Environmental Impact Statement – Supplementary Report

NOLANS PROJECT
ARAFURA RESOURCES LTD

OCTOBER 2017

Figure 3-4 Riparian vegetation impact area

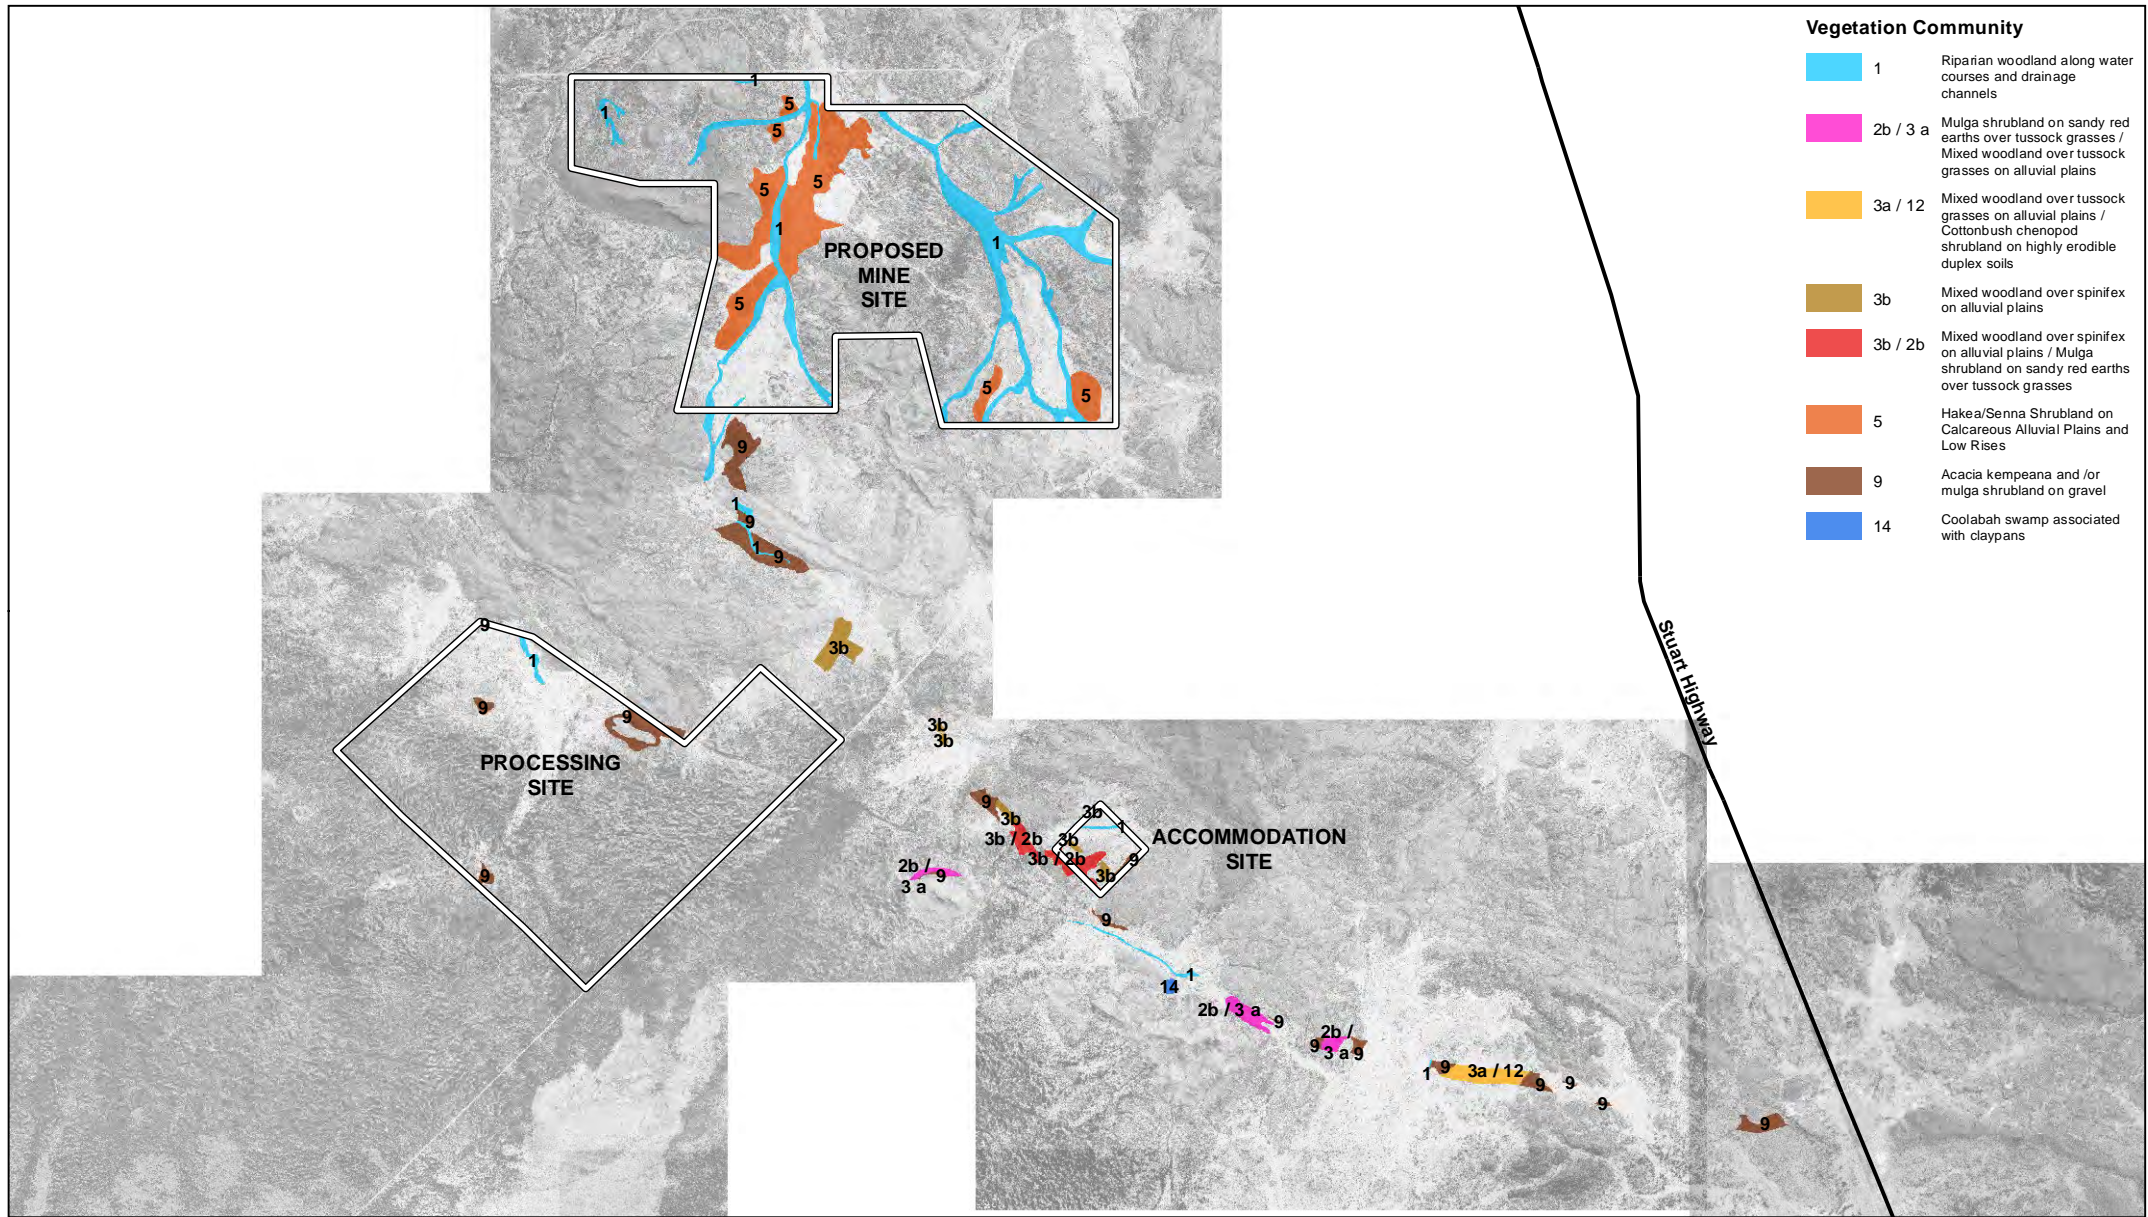
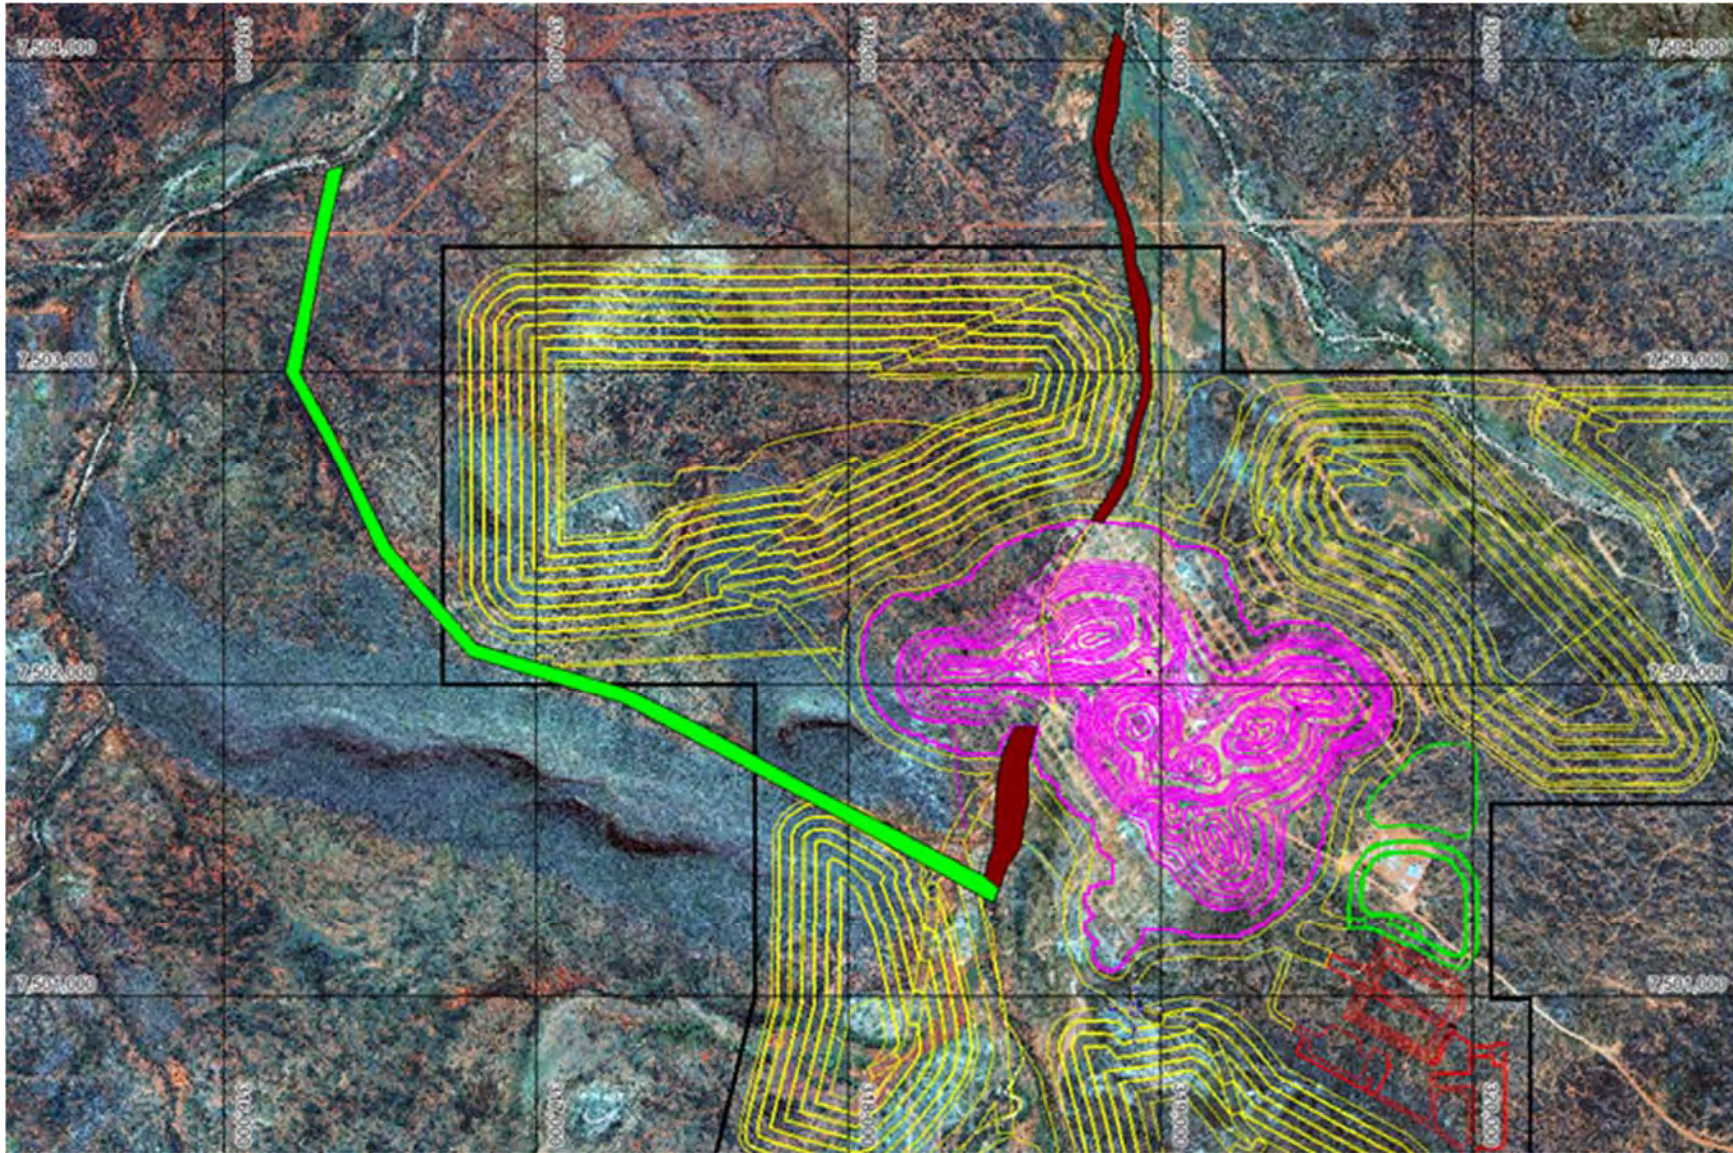
UID	Summary of submission	Response
	change in direction of the diverted creek described in the report, please discuss why this was selected.	demands of the project and to minimise the risk of contaminating creek flows, without significantly effecting the proposed mining operations. Additionally, the topography, drainage and hard rock suit a diversion in this location. The proposed diversion will include flood protection bunds to separate the clean water within the diversion from the dirty water generated by the adjacent mining areas. The final detailed design will be designed by a suitably qualified engineer to provide adequate erosion and scour protection.
235	Riparian vegetation impacts a) Clarify what the area (ha) of riparian vegetation is which will be irreversibly impacted by the Kerosene Creek Diversion.	<p>The riparian vegetation corridor along Kerosene Camp Creek is variable in width. In some places it is constrained and limited to a narrow ribbon along each side of the creek, in other places it widens a little or is spread out as the creek itself opens into multiple flood out channels. Riparian vegetation has been mapped in the project footprint (Figure 3-3).</p> <p>The riparian vegetation immediately adjacent to the mine area, both upstream to the point of the diversion and downstream in Kerosene Camp Creek to the confluence of Nolans Creek is likely to be significantly impacted by the mining operations (i.e. riparian vegetation will die and not recolonise the area). This is depicted in Figure 3-4 as the brown area. A reasonable estimate for the down gradient extent of this impact is based on the point where Kerosene Camp Creek receives additional surface water flow from adjacent catchments. This point is the confluence with Nolans Creek. This length of Kerosene Camp Creek beyond the mining area is approximately 1 km long. The estimated total area of impact is 11 ha, therefore approximately 11 ha of riparian vegetation will be irreversibly impacted by the Kerosene Creek Diversion.</p>

Figure 3-5 Baseline dust deposition seasonal variation (based on normalised monthly values)

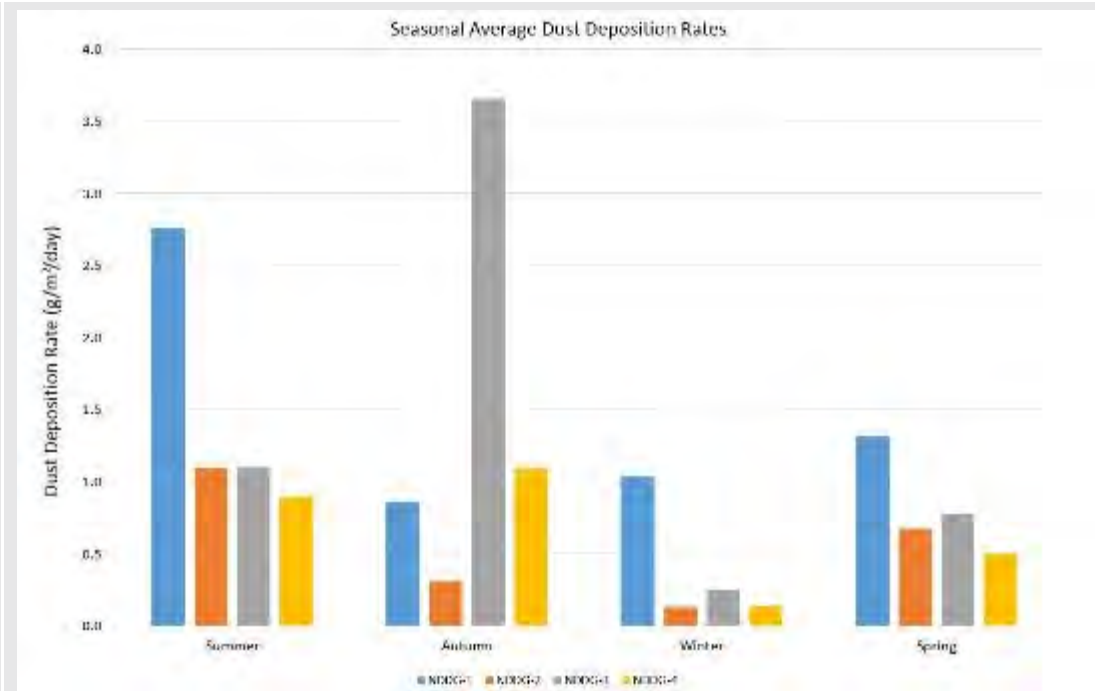
UID	Summary of submission	Response
3	<p>Provide details on whether dust deposition gauge (DDG) equipment and monitoring was conducted according to Australian Standards AS/NZS 3580.10.1. The data presented in Figure 13-2 shows DDG's were not sampled monthly and baseline monthly seasonal variation year to year has not been provided. Fourteen monthly events were recorded off site above the assessment trigger which indicates dust impact will require management from mining activities. Provide details on other sources of dust generation other than the WRDS which may include the topsoil stockpiles, ROM, roads and traffic, processing plant and TSF/residues (if they do not have wet cover).</p>	<p><u>Part A</u></p> <p>Dust deposition gauge (DDG) equipment and monitoring was completed according to AS3580 specifically including AS3580.10.1, AS3580.10.2 and AS3580.14.</p> <p>DDGs were sampled over the two different periods of continuous monitoring:</p> <ul style="list-style-type: none"> • October 2010 to August 2011 and • August 2012 to June 2015. <p>AS3580.10.1 has a period of exposure for routine monitoring of typically 30 ± 2 days (Clause 7.3). However, due to practical considerations, the sampling period (t) in the number of days is a variable in equation 9.1 of the Australian Standard. Site issues associated with collecting monthly in a remote area were catered for by extending beyond 32 days. As long as the bottle does not overflow with rain, (soluble matter determination is invalid) and bottles are 'sun-shielded' to protect for algal growth, the deposition determination over a longer period than 32 days can be legitimately normalised to a monthly value. However, routine monitoring when the mine is operational is recommended on the first day of the month, so as to meet the typical exposure period of 30 ± 2 days.</p> <p>Figure 13-2 in the EIS outlines the baseline monthly variation (based on normalised monthly values) for a period of three years between August 2012 and June 2015 (plus 2010/2011).</p> <p>Baseline seasonal variation (based on normalised monthly values) for the period of monitoring is presented in Figure 3-5.</p>

Figure 3.9

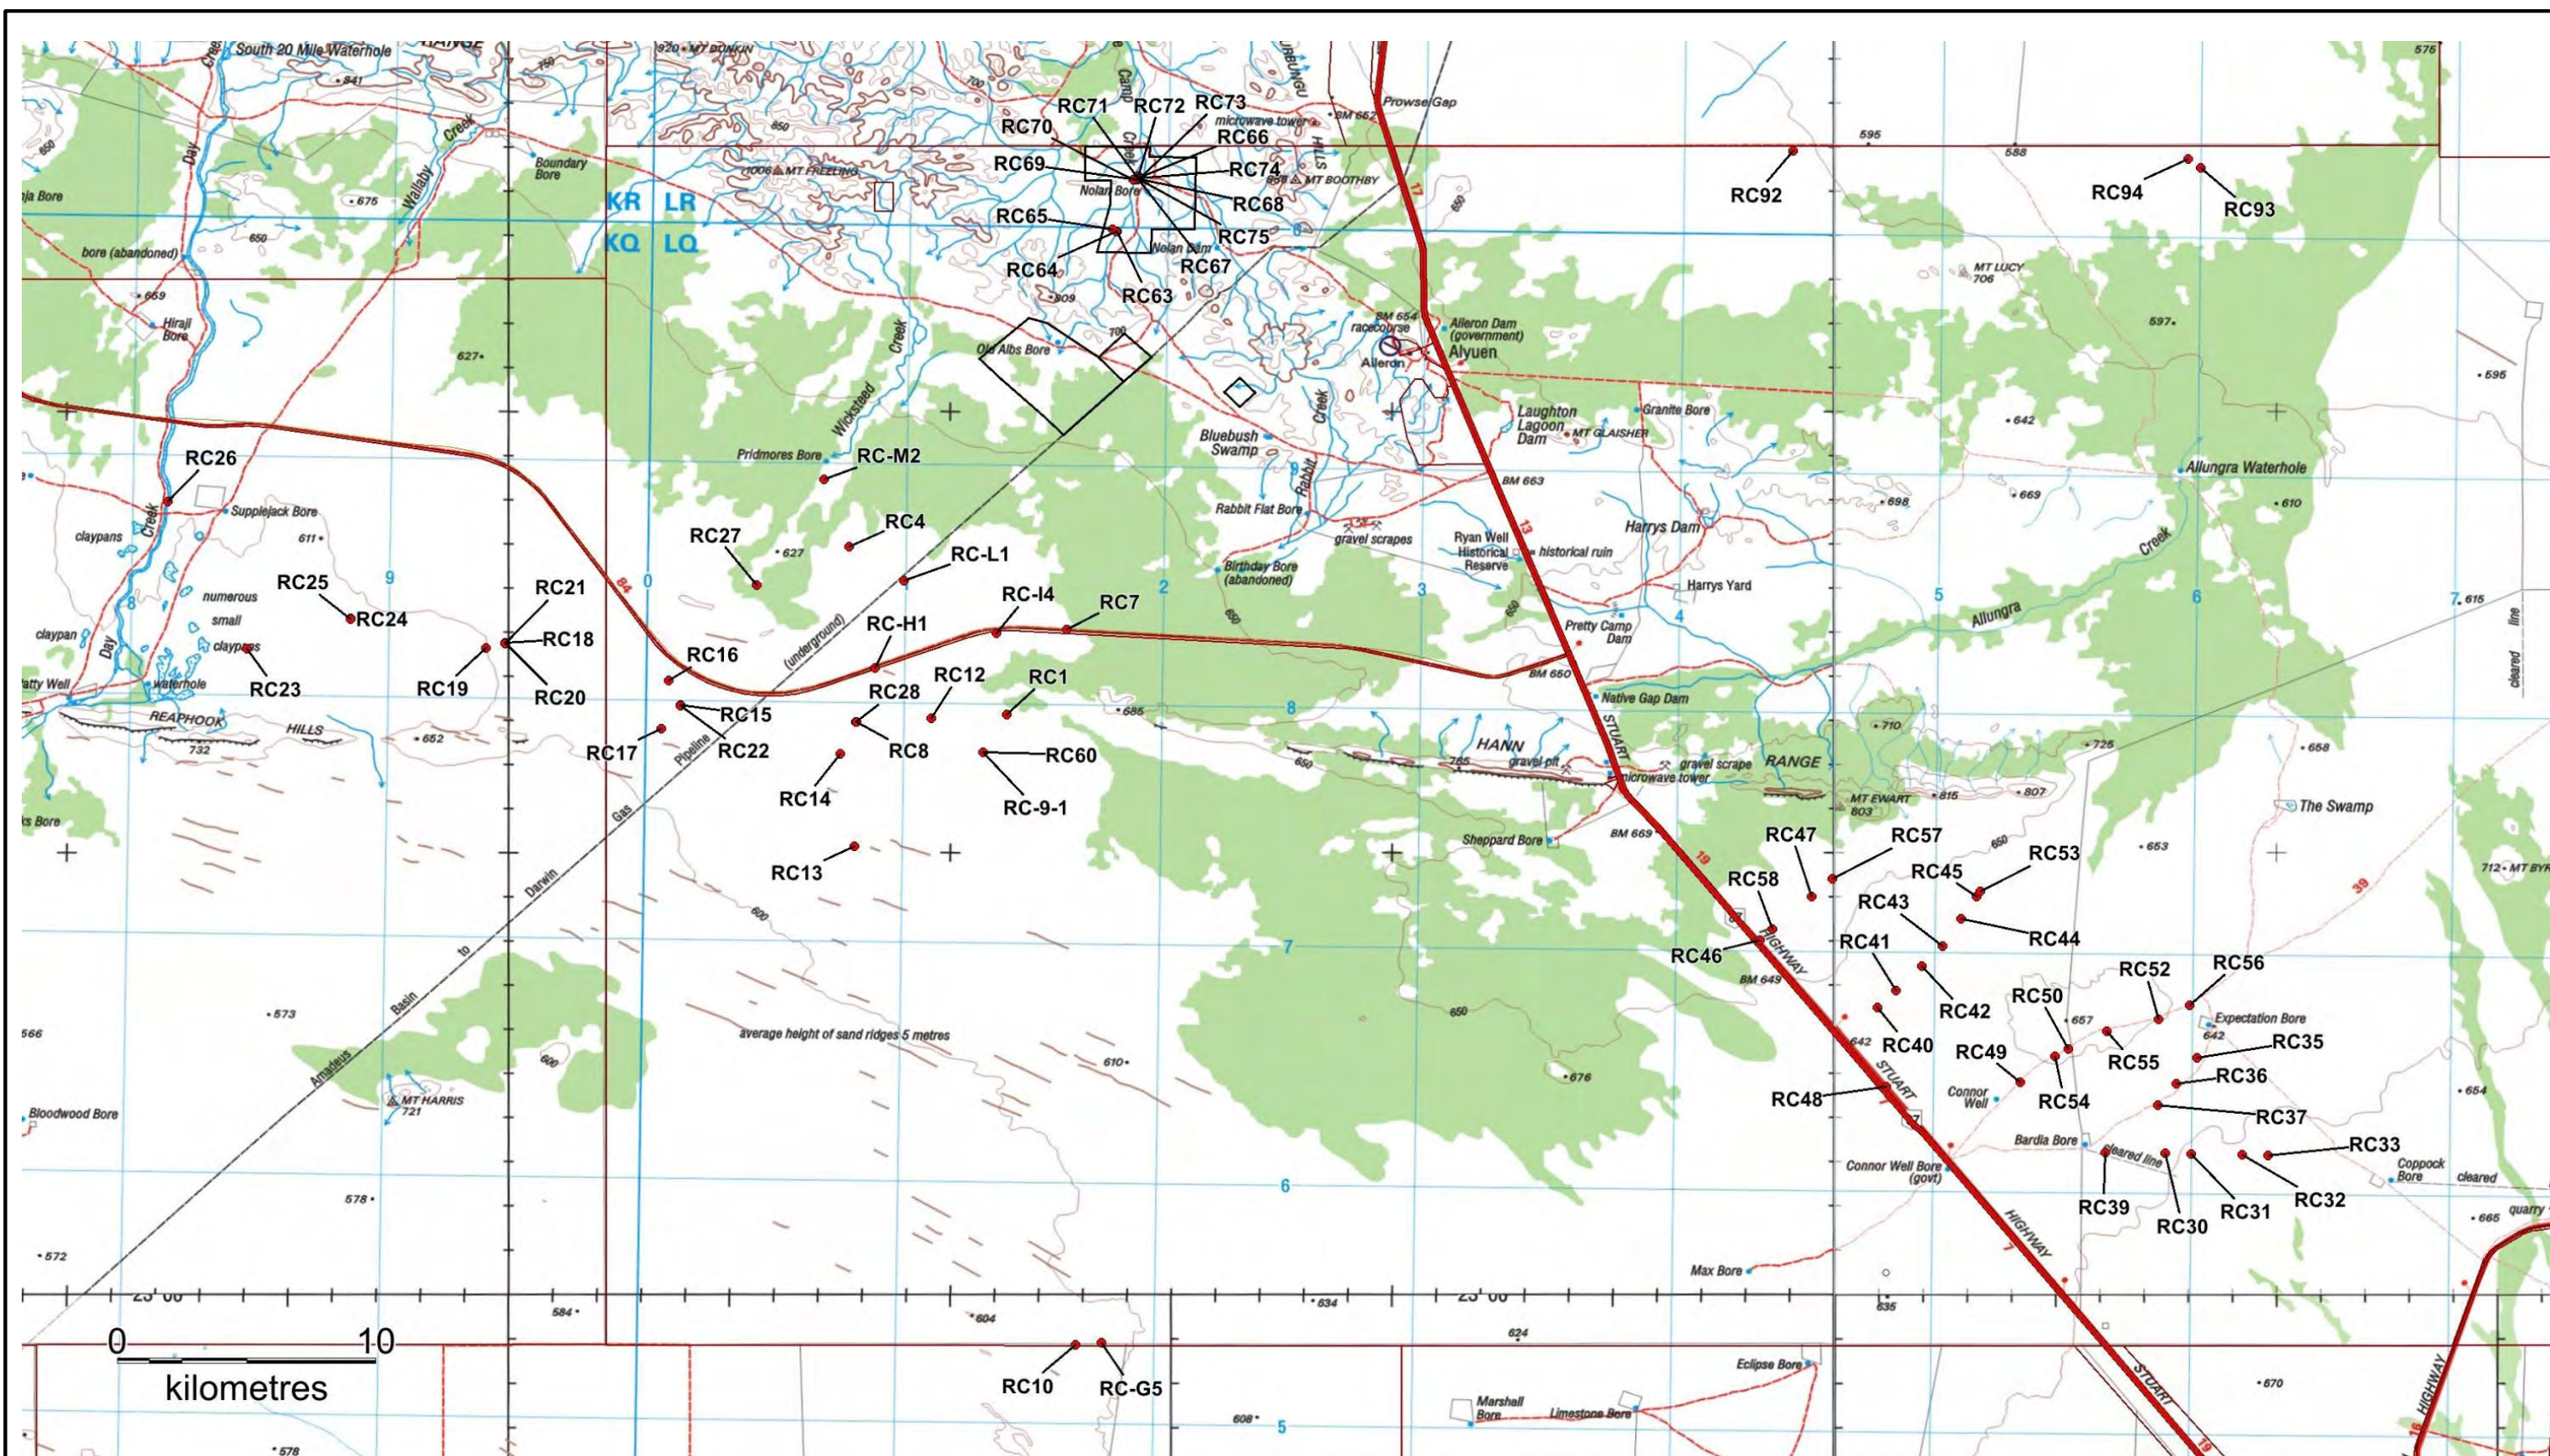
150	75 water bores were drilled specifically as part of the project investigation which is a large dataset to use for early scoping. Are the locations of these bores provided on a specific map? This would help to understand the spatial coverage of the extensive work.	The location of water bores drilled as part of the Nolans investigations are depicted in Figure 3-9.
